LANDMARK COMMISSION

FILE NUMBER: COA-26-000047
LOCATION: 3604 Meadow St.
STRUCTURE: Non-Contributing
COUNCIL DISTRICT: 7
ZONING: PD-595

Courtesy Review (CR) -- Construct a new main residential building (on a vacant lot).

TASK FORCE RECOMMENDATION REPORT
WHEATLEY PLACE / TENTH STREET / QUEEN CITY

ELEVATION PLAN

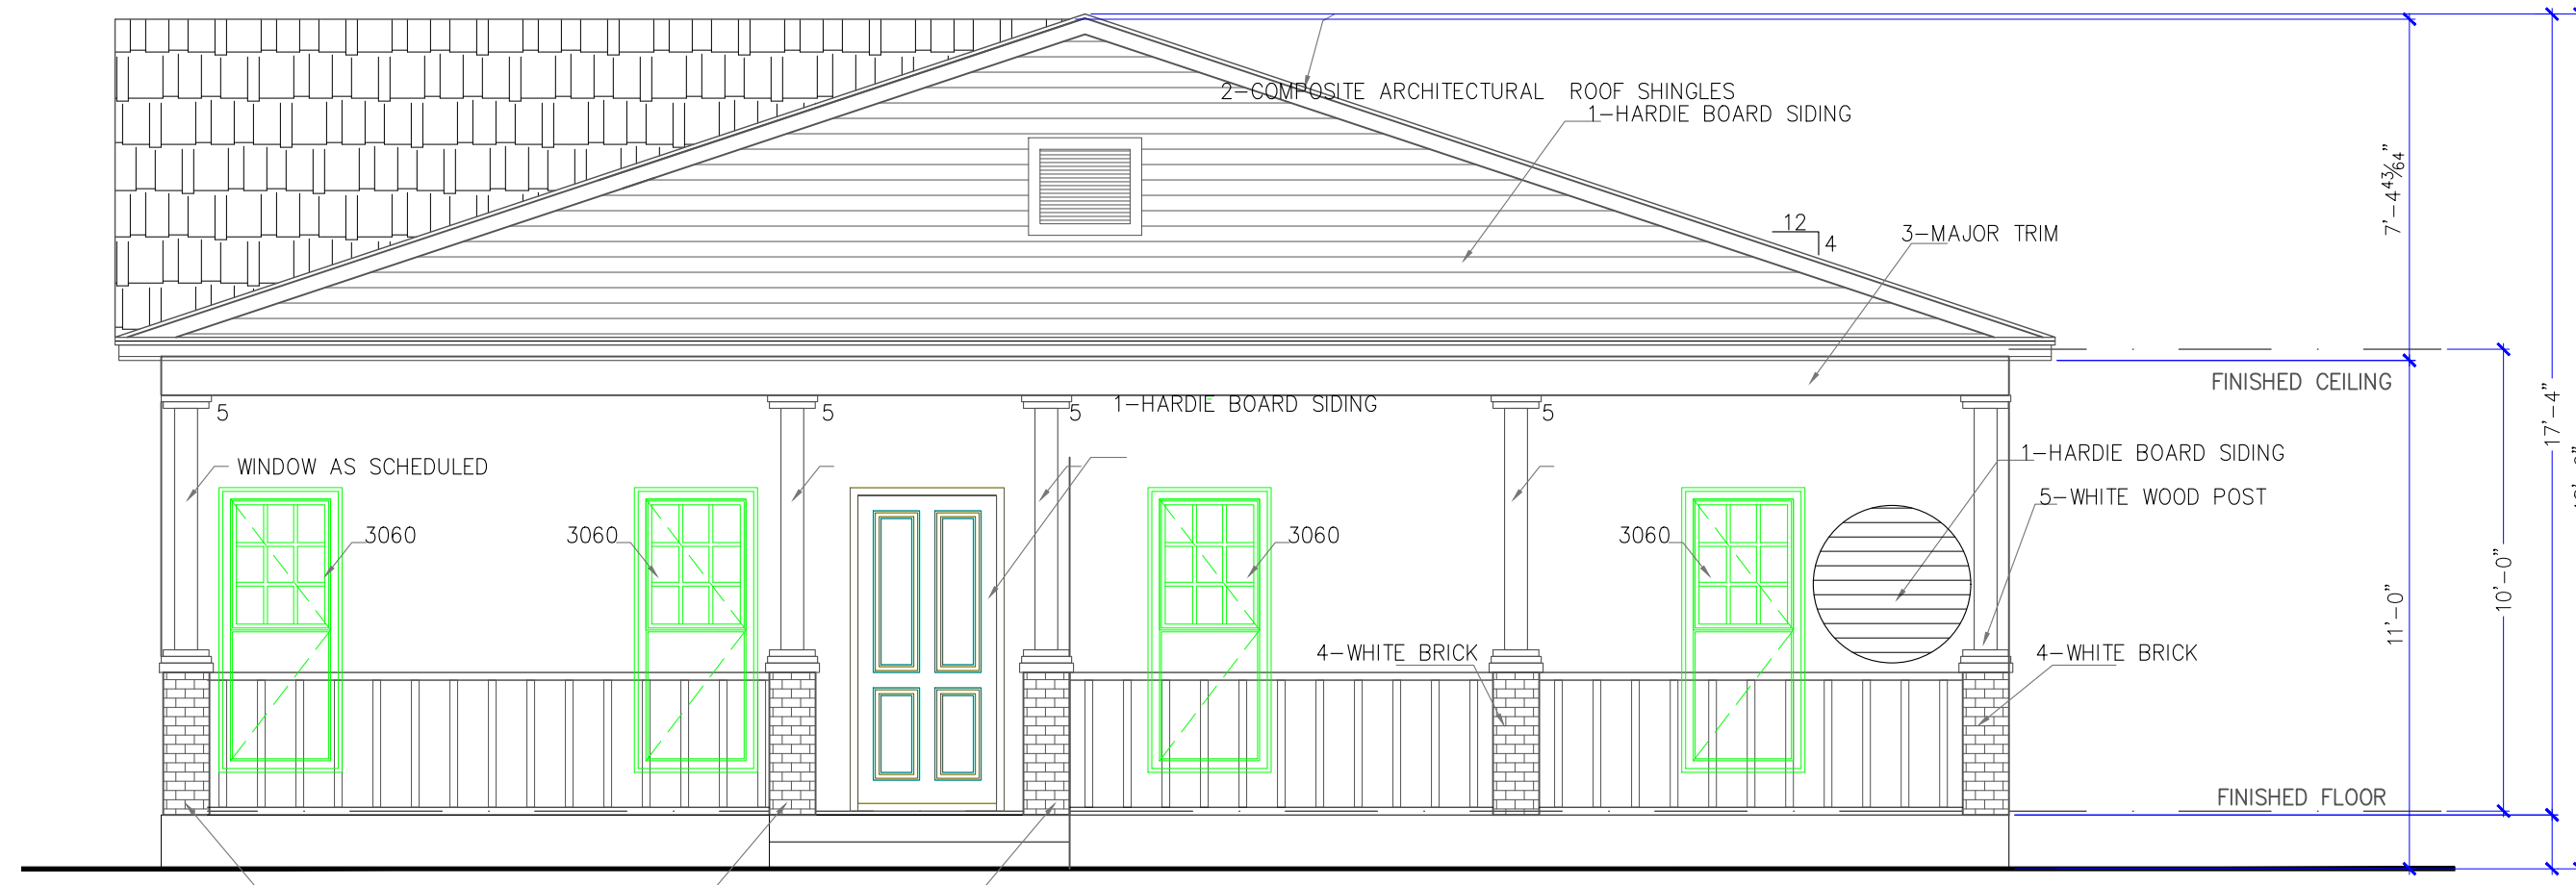
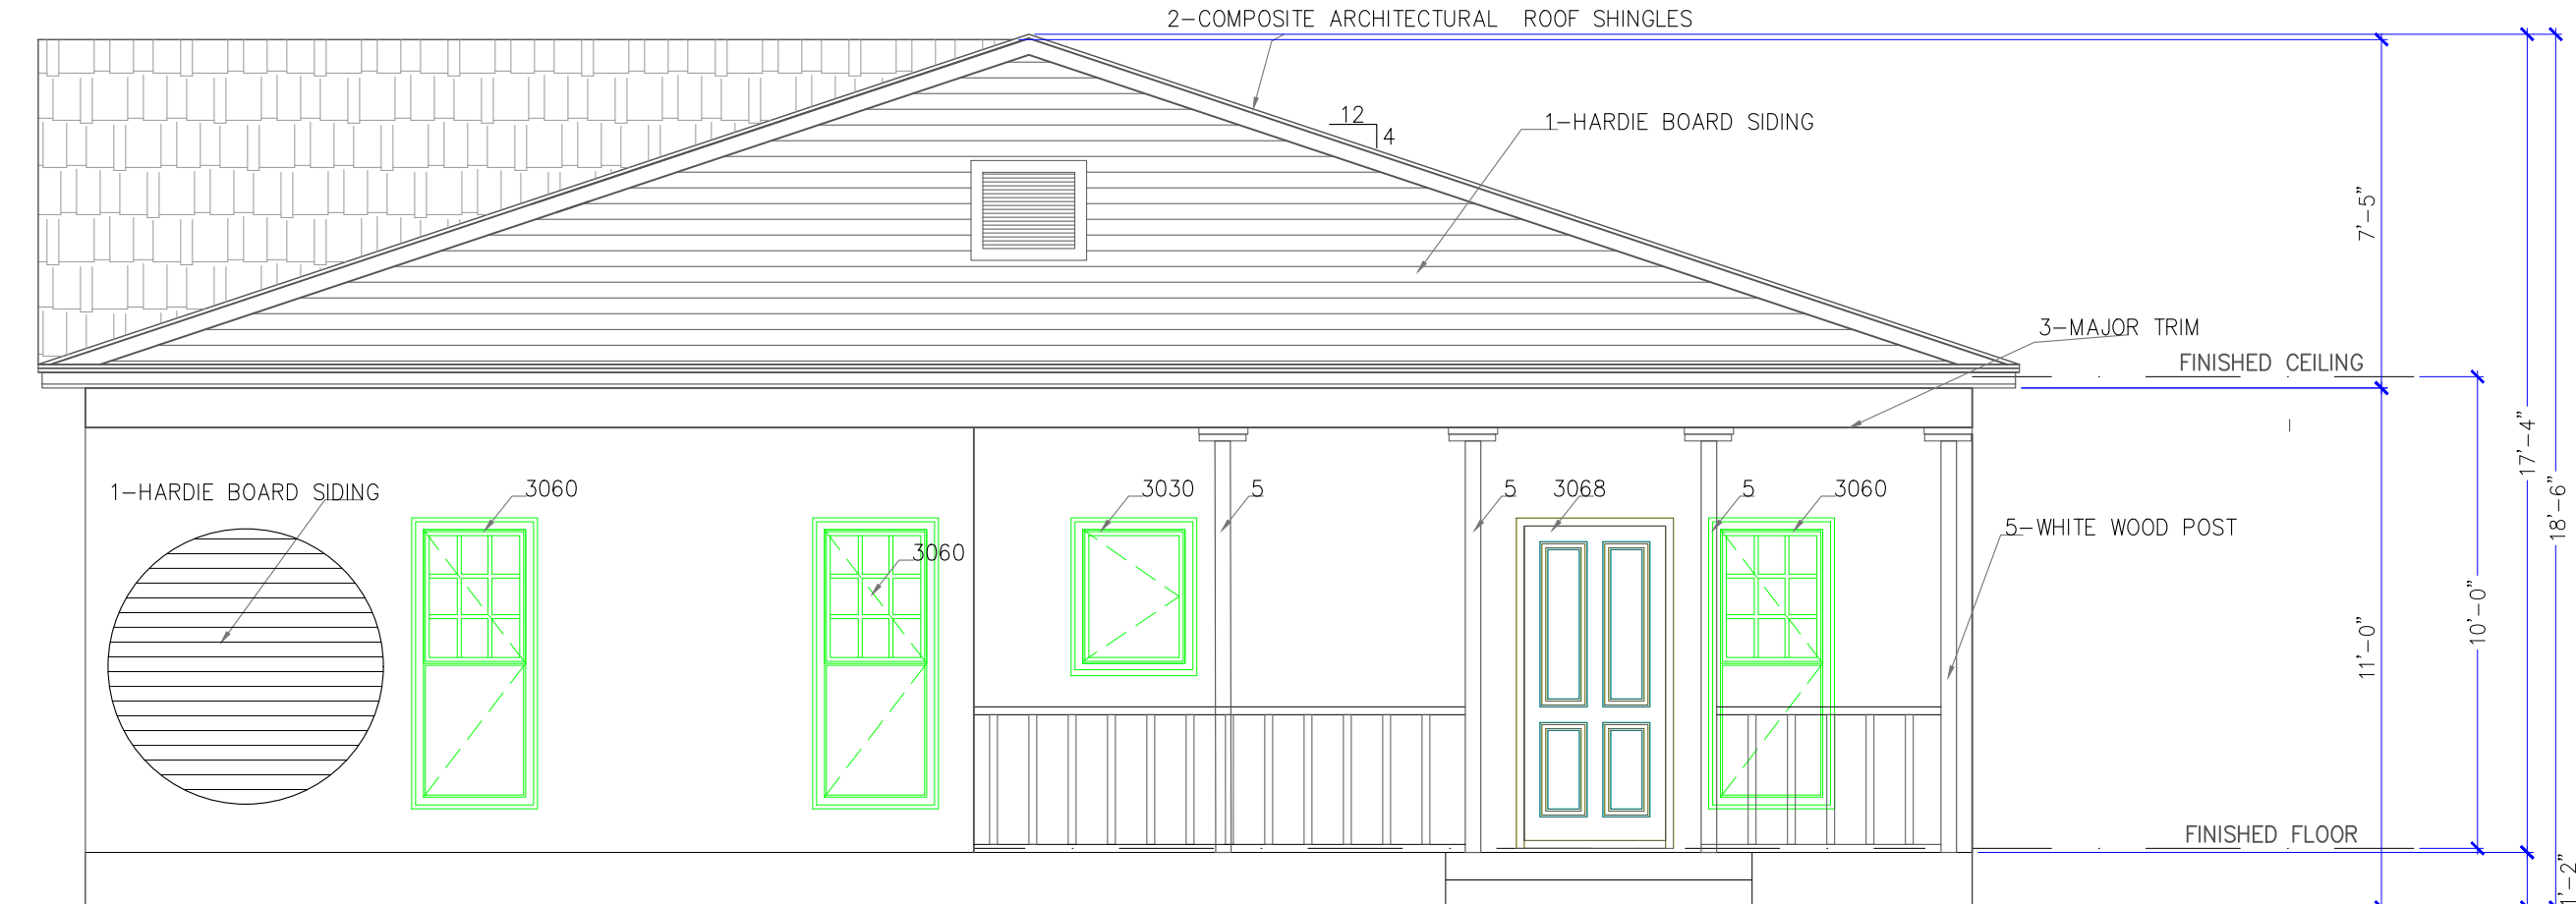
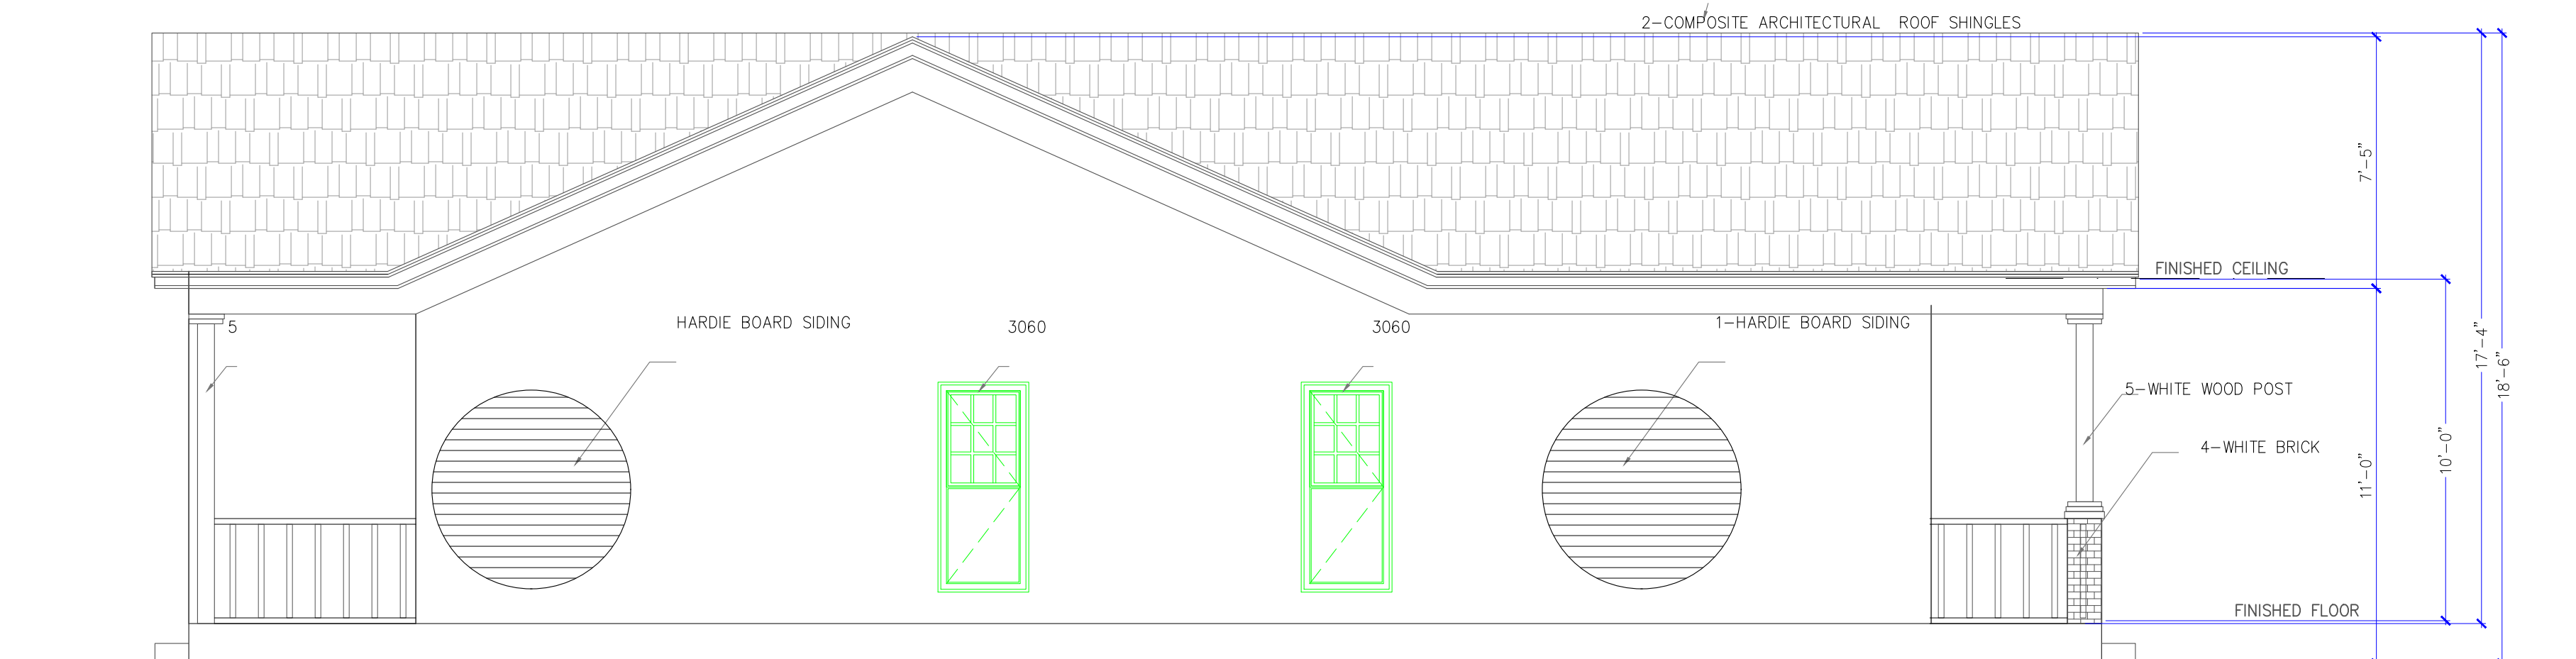
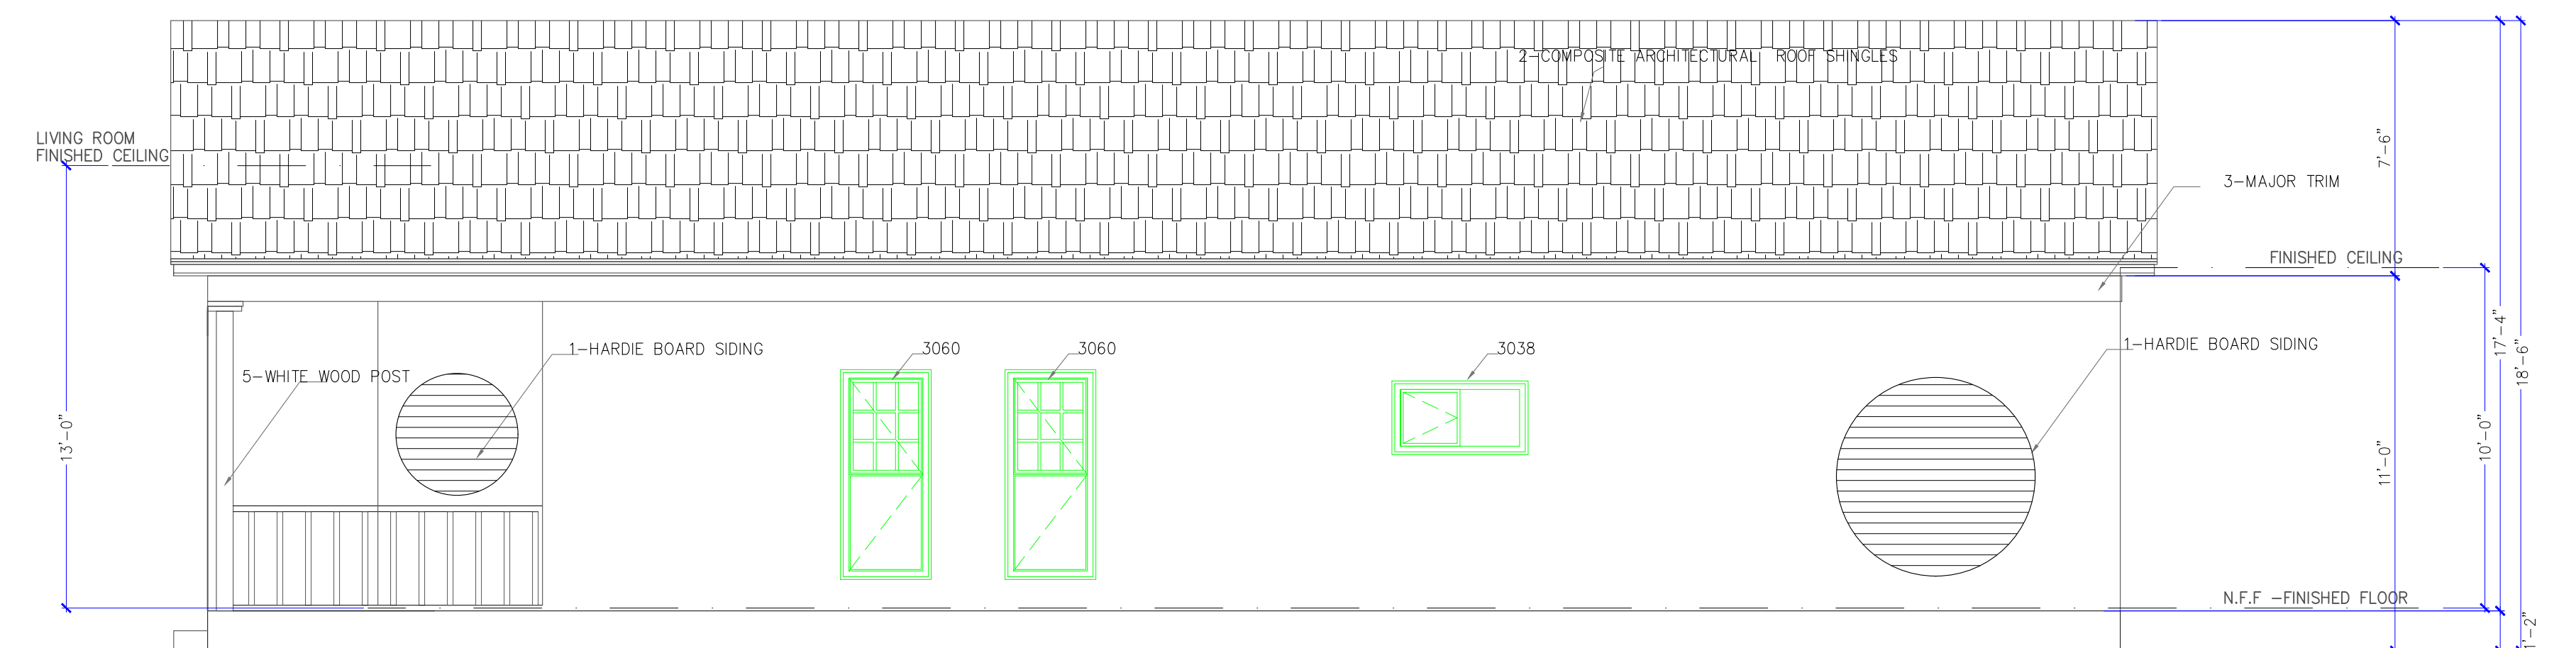
Courtesy Review – Comments only. Non-Supportive, with the following comments:

1. Architectural style is undetectable.
2. Style of main building is NOT appropriate for the district.

Not Supportive

Hardy - No, 9/1 windows, change position of windows
Wrong Column with wrap 3/6 window head height
Style ~~is~~ inappropriate for district
more details expose rafters tails more
